From: M. Junghans Project #: 12168.00

cc: David Stewart, Boston Properties Re: Ames Street Residences Article 19: Special Permit Project Review

Date: February 4, 2015

Response to Comments

Figure 1c

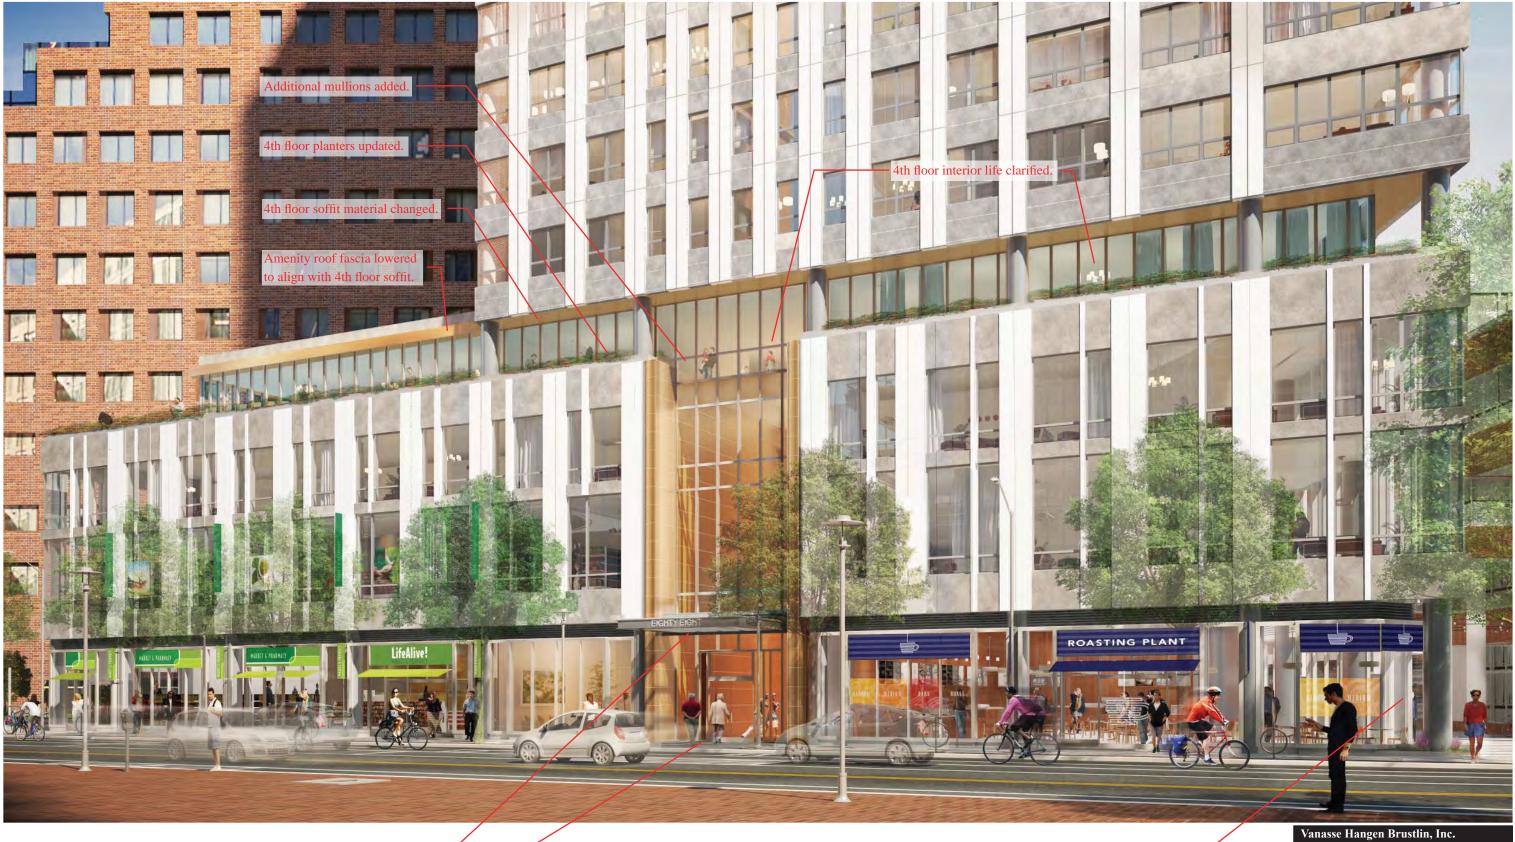
4th floor soffit material changed

Amenity roof fascia lowered to align with 4th floor soffit.

Podium elevation simplified by replacing punched louvers with full louver wall.

Landscape updated. —

Hubway added. —

Figure 1d

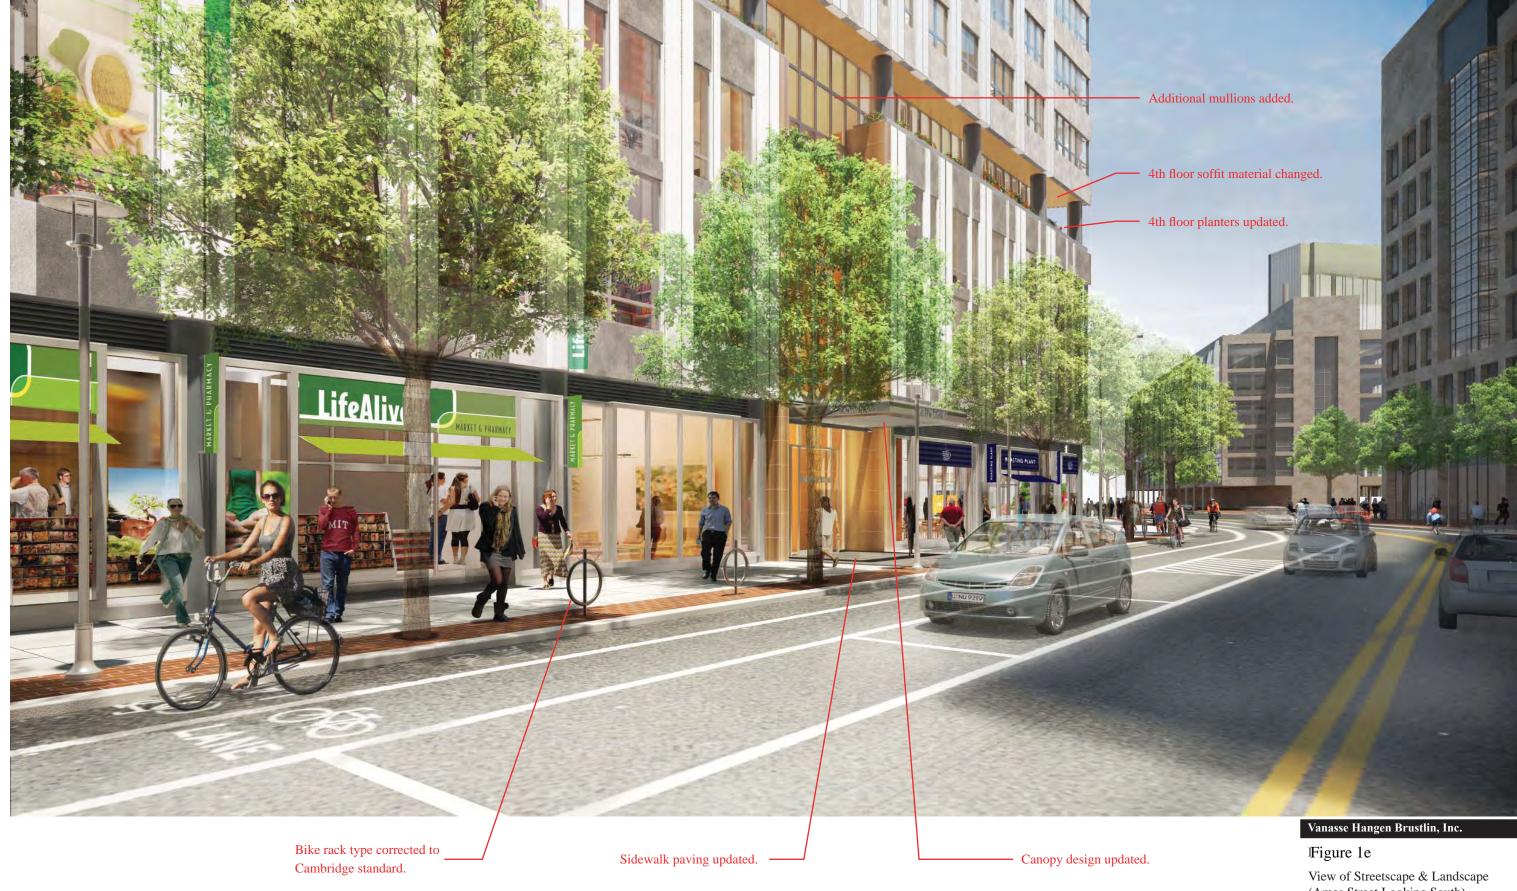
Canopy design updated.

Sidewalk paving updated. -

Storefront corner opened to provide vehicular sightline.

Figure 1h

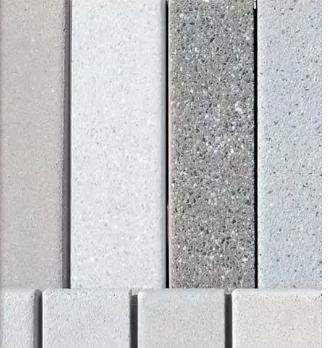
Landscape planter, plantnigs and tree updated.

Figure 2a

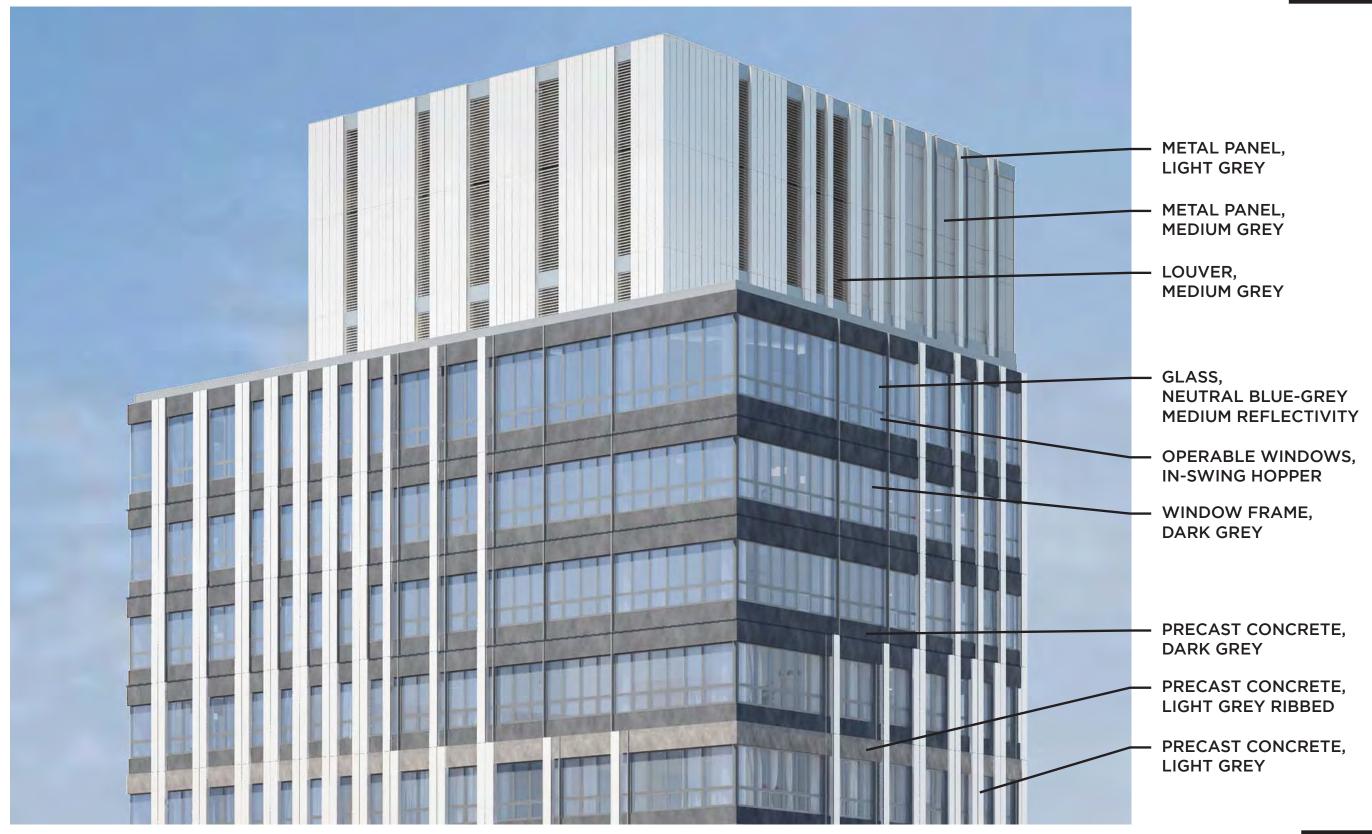
2. Precast Concrete - texture variation - Material colors adjusted. -

- Additional materials shown.

Figure 7c

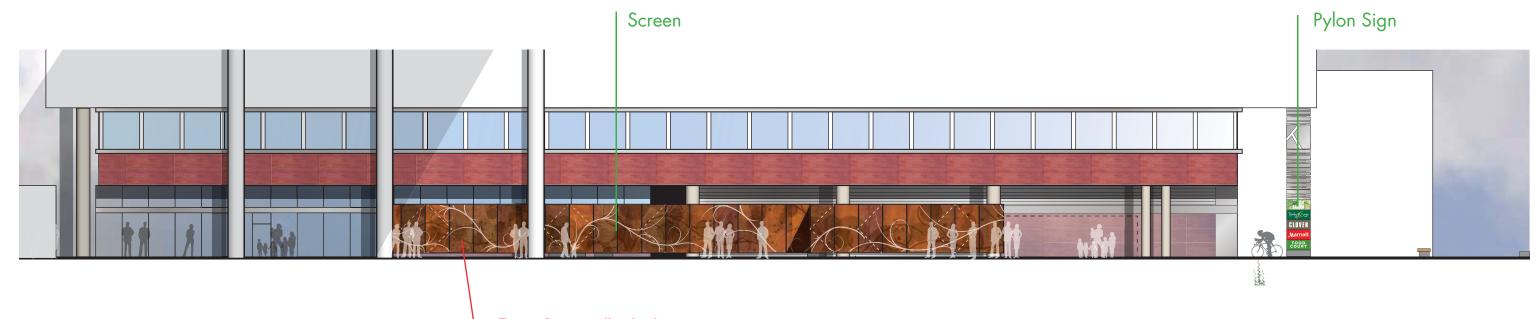
Extent of screen wall updated.
